Case No. 11-133Z

Stone Hollow

CASE 11-133-Z
GENERAL DEVELOPMENT PLAN

Staff Recommendation

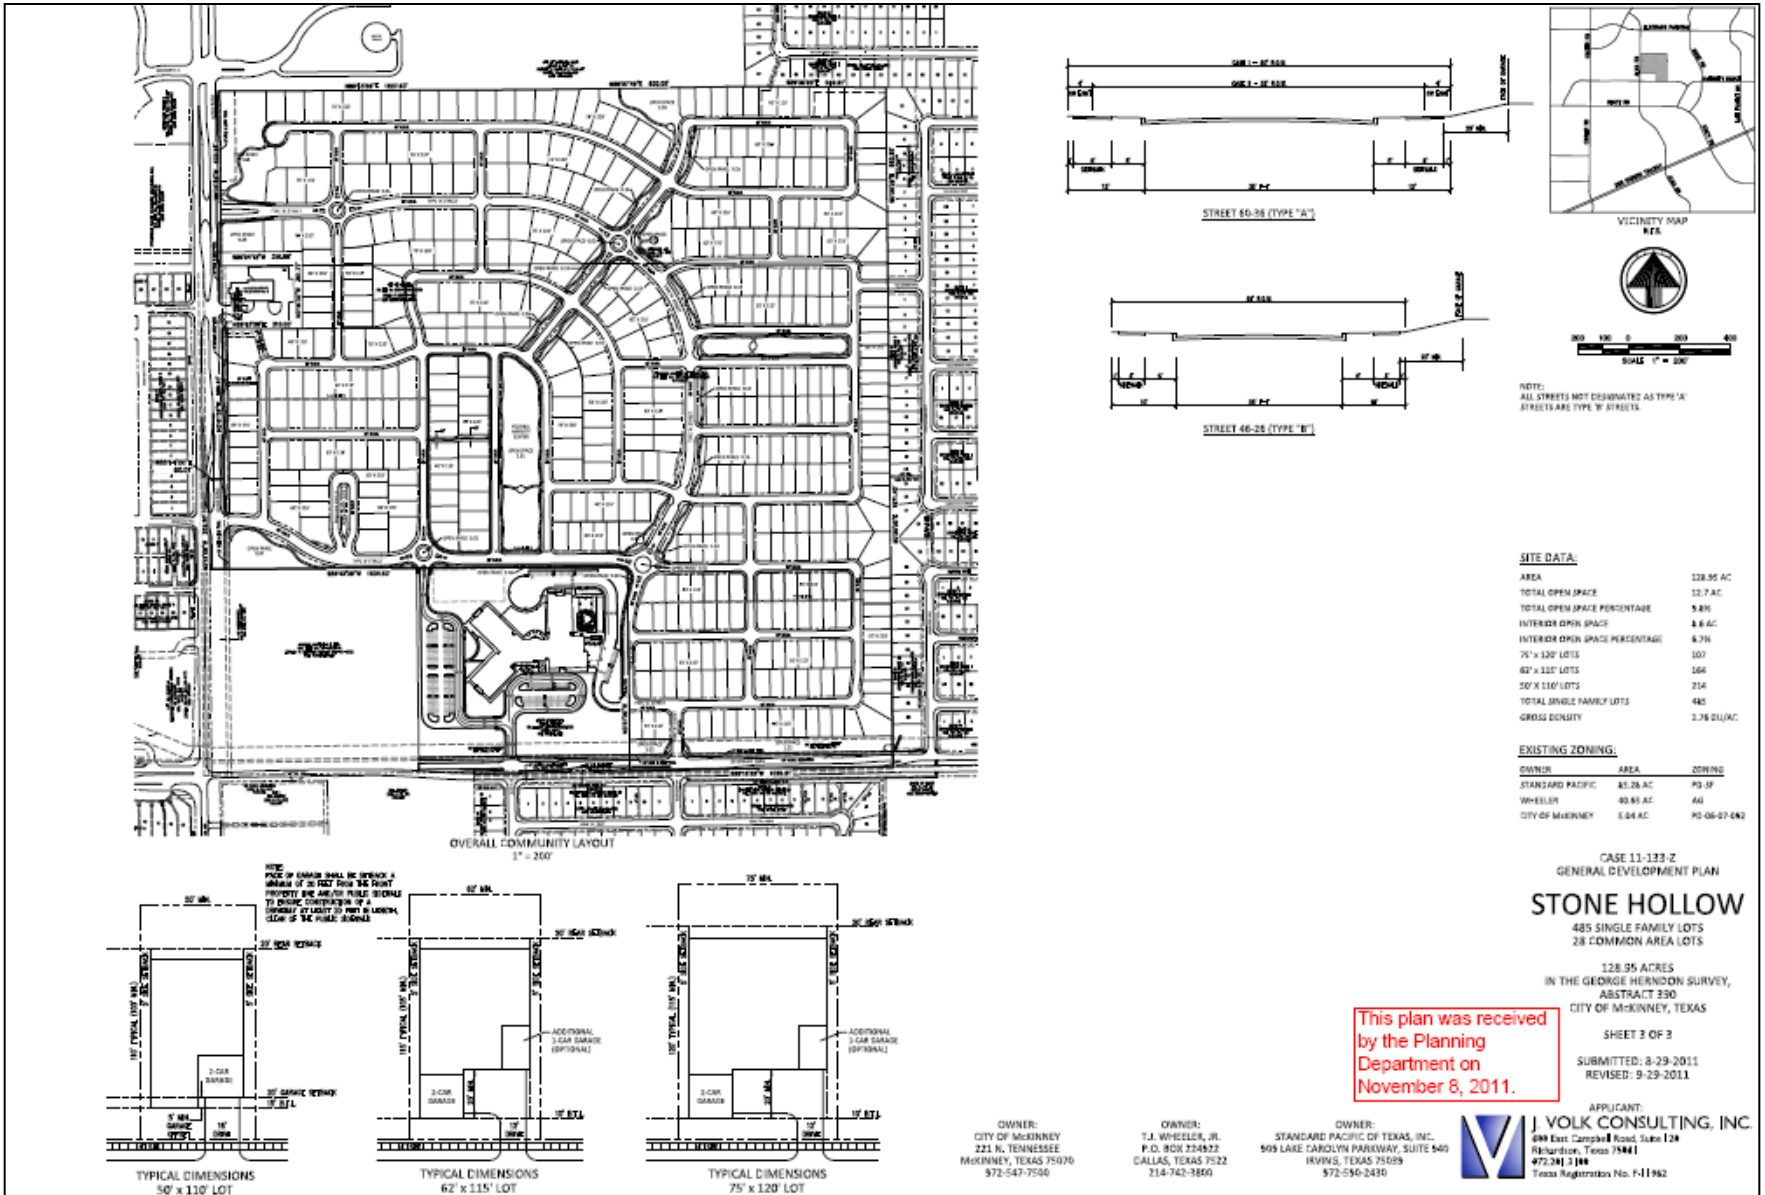
- Staff recommends denial of the proposed rezoning request due to nonconformance with the character prescribed by the “REC” – Regional Employment Center Overlay District. Staff feels that by reducing the required garage/façade offset for the proposed 50’ wide lots to five feet and for proposing a dead-end street, the rezoning request is in direct conflict with the design guidelines and intent of the REC.

- The subject property shall generally conform to the attached general development plan.
- The subject property shall develop in accordance with the attached development regulations.
- The subject property shall generally conform to the attached entryway exhibits.
